GATWICK AIRPORT NORTHERN RUNWAY PROJECT

**Legal Partnership Authorities Response to Actions Arising
at ISH8 [\[EV17-018\]](#)**

Comments on Design and Access Statement - Appendix 1 -Design Principles (DP) Version 4 [REP5-031]

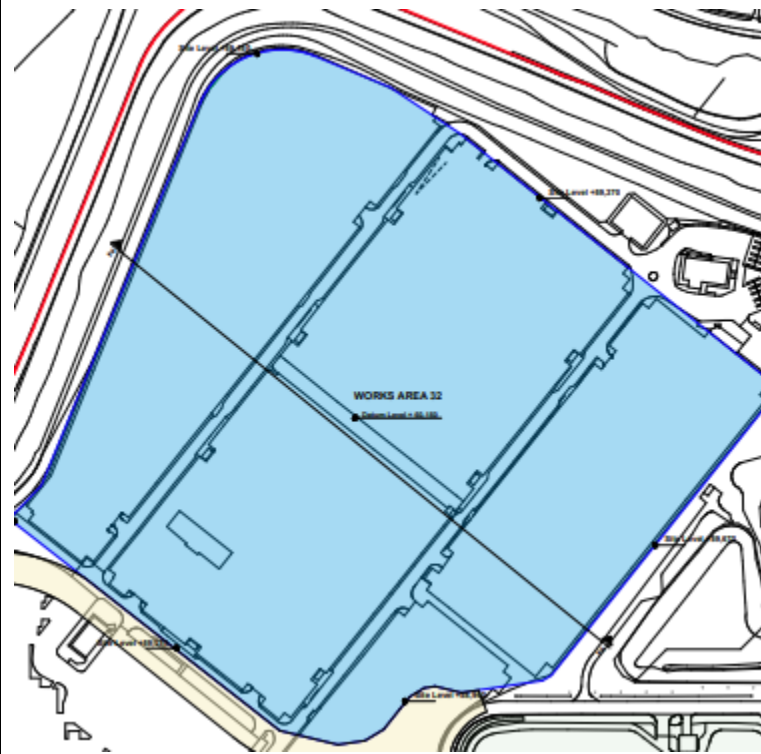
The western edge of the area is hard up against a line of trees which provide screening for nearby properties and the Grade 2* listed Charlwood House. According to article 6(1) of the draft DCO, the decked parking structure could be located hard up against the any of the blue work boundaries shown on the works plans.

Work No. 32 is one of the works listed in article 6(3) of the draft DCO. This means that in constructing it, the undertaker must not exceed the maximum heights shown and noted on the parameter plans (those heights being listed for information only in Schedule 13, mentioned above).

2 Parameter Height Section 2
1 : 750

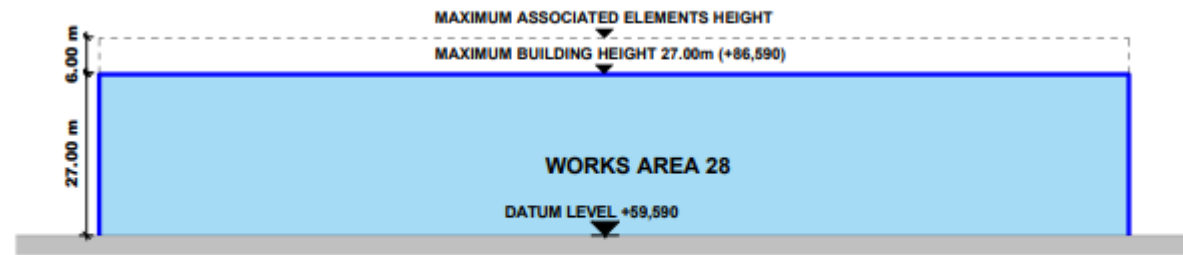
This means that the whole of the decked parking structure along that cross-section, up to the western edge, could be up to 11 metres above datum level. In addition, as the Authorities understand it, any ancillary or related development of the type listed at the end of Schedule 1 to the DCO could be added on top of the structure, including (paragraph (e)) structures and plant, signage, CCTV poles and mountings, lighting poles and fittings “and any other permanent works required”. The Authorities note that for Work No. 28 (Car Park H Site), the parameter plans show, for “associated elements”, a dotted line above the maximum

building height level (see illustration below), and this is also noted in the relevant entry in Schedule 13. It is not clear from the DCO or the plans whether this means that the Applicant does not intend to provide any associated elements on the top of structures where no such dotted line is shown. This could be made clearer in the DCO, the parameter plans and in Schedule 13.

So in order to meet the Authorities’ concerns, there would need to be a change in which Schedule 13 is structured. For example, rather than it being simply illustrative of what the parameter plans say, instead it could impose detailed restrictions on the parameter heights at certain places within the works area and impose restrictions on what ancillary and related development may be constructed (if any) above the parameter heights for each work. Or the authorities’ objective could be achieved by changes to the works plans and/or parameter plans themselves, or to article 6 (limits of works) to the DCO, in the case of “associated elements”.
